TECHNICAL INSTRUCTION

TI 156
Issue 1
24/02/2011
Page 1 of 2

NETWORK RAIL - SIGNAL ENGINEERING

New Fine Packing Shim For Clamp Locks

Figure One

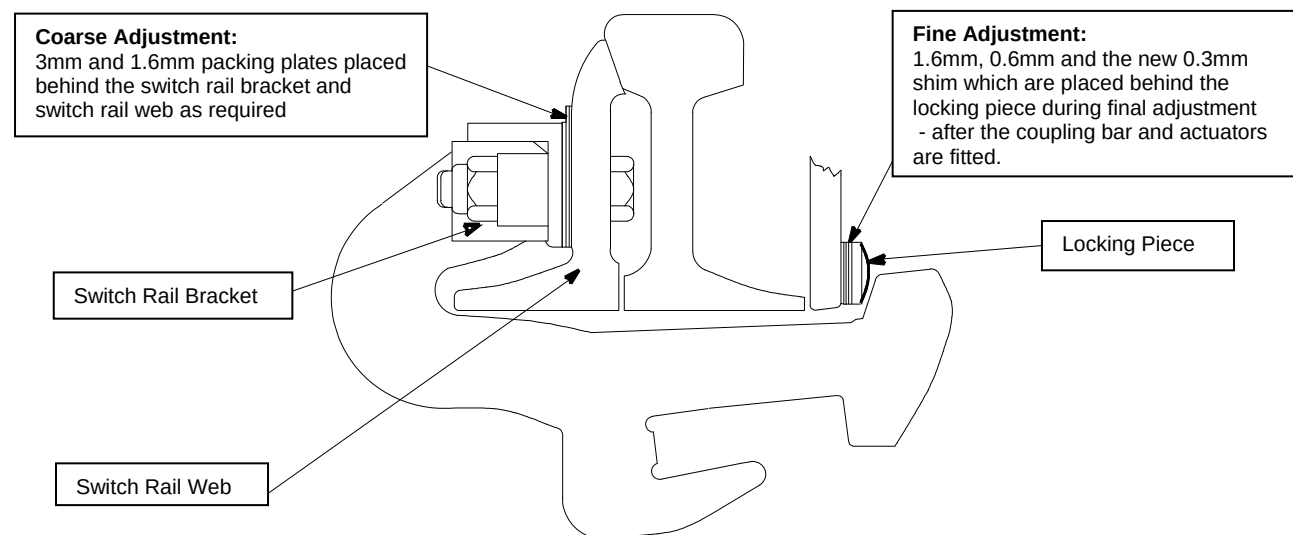
All Clamp Lock installations, including the more recent In-bearer design, use fine packing shims which fit behind the locking piece as illustrated in figure one. The information within this TI applies to staff responsible for the installation and maintenance of the Clamp Lock mechanism.

Originally there were two fine packing shims available, 0.6mm and 1.6mm. The introduction of a 0.3mm shim provides greater flexibility and reduces the risk of having a tight lock set-up, which can affect the performance of the Clamp Lock Mechanism.

The fine packing is inserted behind the locking piece to prevent the drive lock slide from completing its travel when the 3.5mm Facing Point Lock (FPL) test is being carried out. If the FPL test fails, the fine packing is increased until the drive lock slide fails to complete its travel. In some cases, the original 0.6mm and 1.6mm packing shims have not provided enough flexibility, which has resulted in tight lock issues. The addition of the 0.3mm shim provides a greater range of packing as shown in the table.

The new 0.3mm shim has been added to the Clamp Lock supply list and it is advisable to obtain the new shim so that it can be utilised during the next planned installation or maintenance activity. The introduction of the new shim provides greater flexibility when carrying out NR/SMS/Test 003; however, it does not change the installation procedure as detailed within the Clamp Lock Handbook.
